SERVICE BULLETIN

Classification: BT21-027	Reference: NTB21-118	Date: December 17, 2021
-----------------------------	-------------------------	----------------------------

RESIDUE ON OUTER SURFACE OF FRONT DOOR GLASS

- APPLIED VEHICLES:** 2022 Frontier (D41)
APPLIED GRADES: SV with Convenience Package
All PRO-X and PRO-4X
APPLIED SYSTEMS: All vehicles with external Intelligent Key door request switches

Figure 1

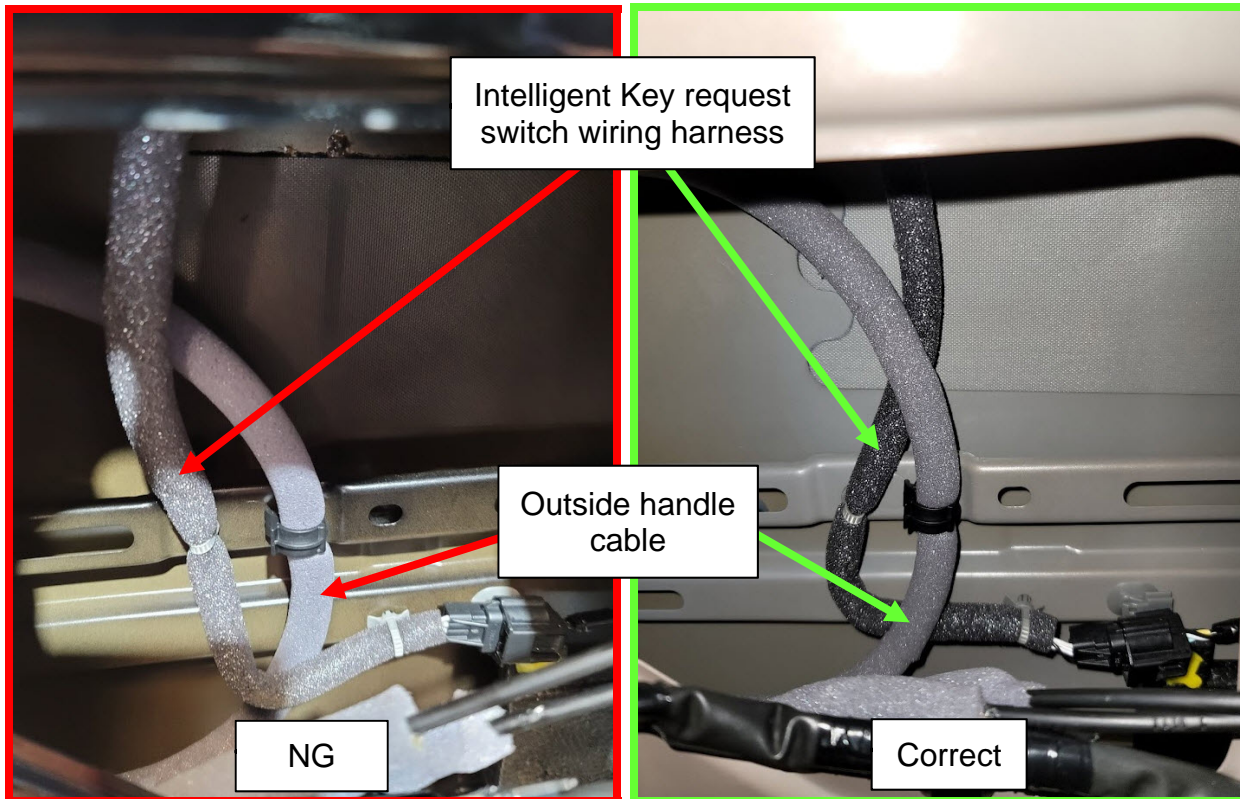
Adhesive residue is found on the outer surface of front driver (LH) side and/or front passenger (RH) side window glass.

1. Remove the door finisher on the affected side.
 - Refer to the **ESM: BODY INTERIOR > INTERIOR > REMOVAL AND INSTALLATION > DOOR FINISHER**
2. Inspect the routing of the Intelligent Key request switch wiring harness and confirm if it is routed as shown in Figure 1.
 - If routed as shown in Figure 1, proceed to step 3.
 - If routed as shown in Figure 2, skip to step 5.

3. Reroute the harness behind the outside handle cable, as shown in Figure 2.
4. Confirm that neither the harness or cable are no longer contacting the glass.
5. Reassemble the door finisher.
